Ballykeeran Gardens, Cornamaddy

Response to Request for Further Information

LRD Amendment Application (LRD Permission 318736-23, WMCC App Ref: 26/60435)

Fig. 03 Extract of permitted Phase 1 layout.

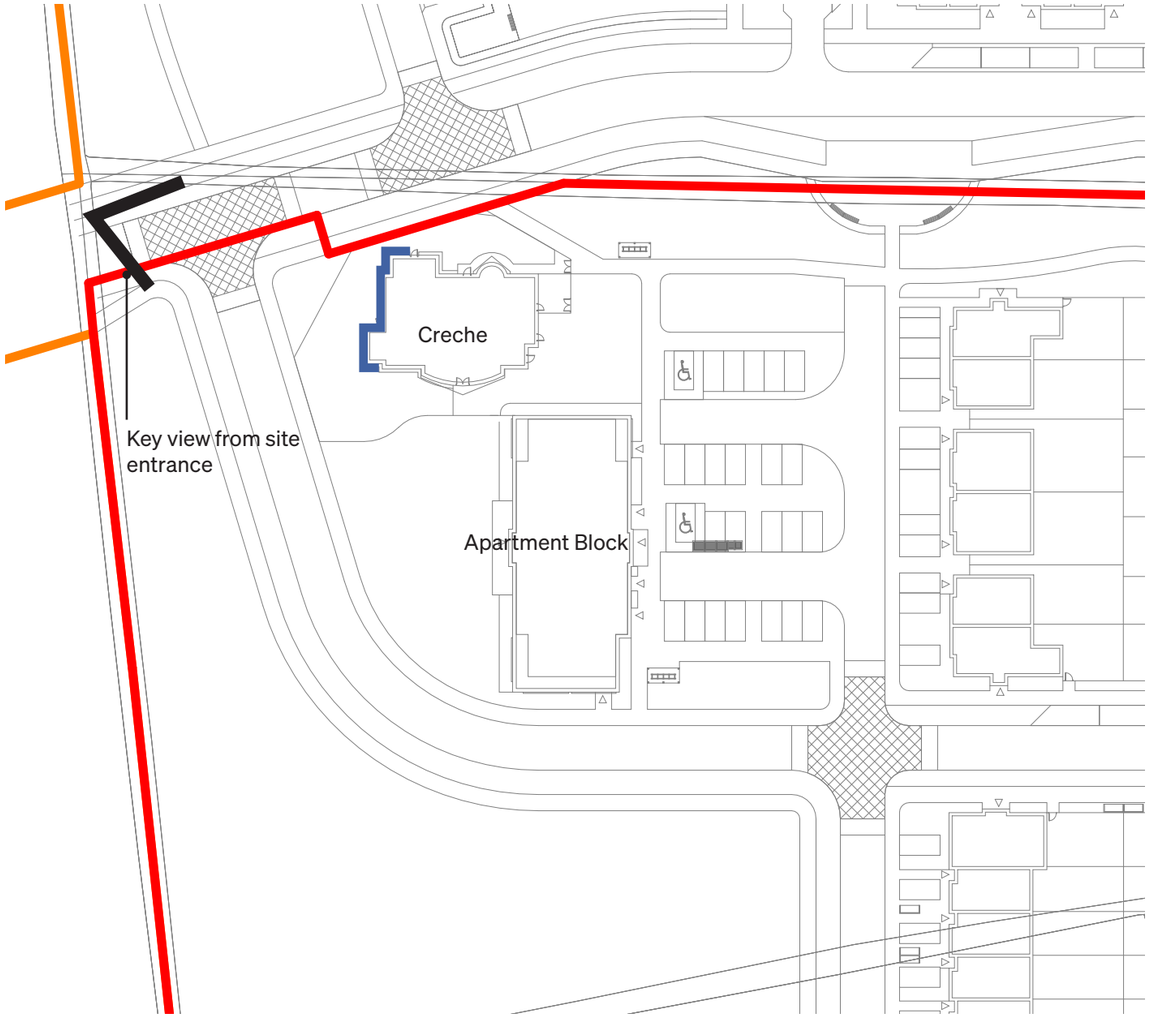
RFI item no.4:

The revised crèche proposal is not considered satisfactory in terms of either siting or architectural treatment. While capacity remains unchanged at 58 childcare spaces, the relocation of the building from the north-western portion of the site has significantly reduced its prominence within the development. Furthermore, the revised design closely replicates the scale, form and appearance of the adjoining semi-detached housing and fails to provide an appropriate architectural identity for a purpose-built childcare facility.

You are requested to submit revised proposals to significantly revise the siting and design of the crèche, including consideration of its relocation to the previously proposed north-western position, as raised at pre-planning stage. The revised building should provide a distinctive, dual-aspect architectural response which positively addresses the main approach road, strengthens the entrance to this phase of the wider large scale residential scheme and contributes to the legibility and character of the overall development.

The proposed relocation of the Creche to the northwest of Phase 1 was determined following the removal of the apartment block from the permitted Phase 1 layout, shown in Figure 03. The layout in the permitted scheme locates the creche to the north of the site and the apartment block to the south of it.

The location of the creche in the submitted layout sought to improve its relationship with the public open space to the south, positioning the frontage of the creche opposite the play area across the main spine road. This provided a functional relationship between the childcare facility and amenity space.

The submitted layout omitted the apartment block and replaced with semi-detached and detached houses. This approach intended to create a soft neighbourhood feel upon entering the development, keeping consistent scale and massing with the westersn side of the site.

In response to RFI item no. 4, the creche has been repositioned to the northwest of the site, consistent with the permitted development as recommended by WMCC.

The relocation of the creche maintains the strong urban frontage into the development, reinforcing the importance and prominence of the creche to the wider scheme. In making this revision, the creche sits at a key corner of the development and separated from the neighbouring houses with the outdoor play space and green pockets, creating a strong entry point into the development. This also allows for the creche to be set apart from the neighbouring properties for an identifiable childcare facility, providing a varied and rich urban layout as a continuation of the varied streetscapes of Phase 1.

To relocate the creche, the houses have been moved to the south and follow the geometry of the main spine road. The green pedestrian route from the submitted layout is retained to provide a safe and accessible landscaped route to the green space at the north and west of the site.

Fig. 10 Annotated extract of the permitted site layout showing retained trees and sketched layout of the third-party land.

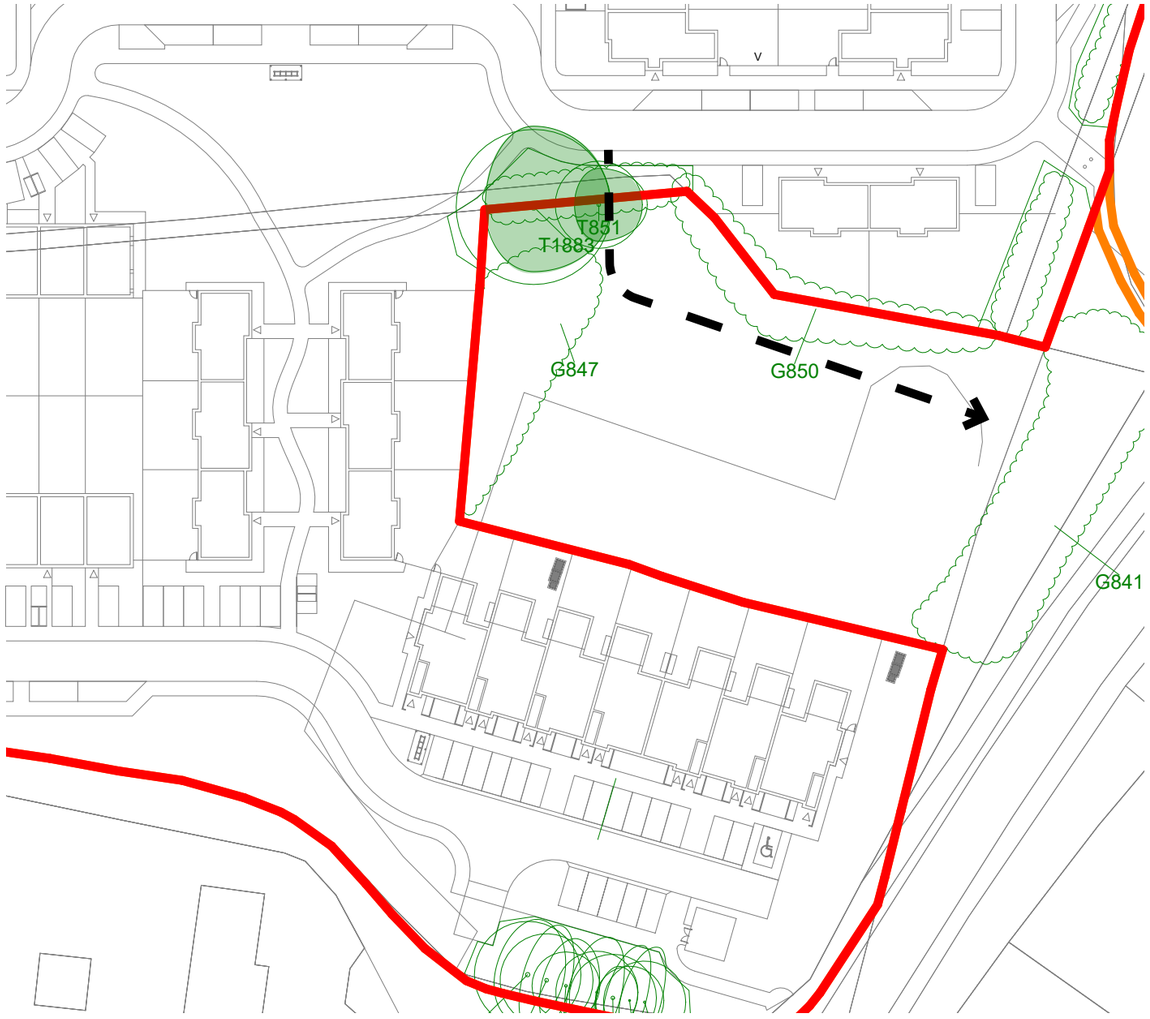
The applicant is requested to submit a revised site layout plan providing for an appropriate and direct access connection from the internal road network to the third-party lands located along the eastern boundary of the application site. As currently proposed, the layout would appear to enclose and effectively landlock these lands, thereby unduly constraining their future development potential.

While the proposed controlled access arrangement is noted, it is considered that the development should revert to the approach permitted under the parent permission, whereby adequate frontage and direct access to the internal road network was provided. Revised proposals shall ensure that the future development potential of the adjoining lands is not prejudiced and shall have due regard to the requirements set out under v above.

The permitted development had allowed for access into the third-party lands from the north, however, as shown in Figure 06, the retained trees would need to be removed to allow for any future access. The sketch demonstrates that the potential layout of this land would result in houses orientated towards rear gardens. This would create an undesirable urban design layout with poor street frontages.
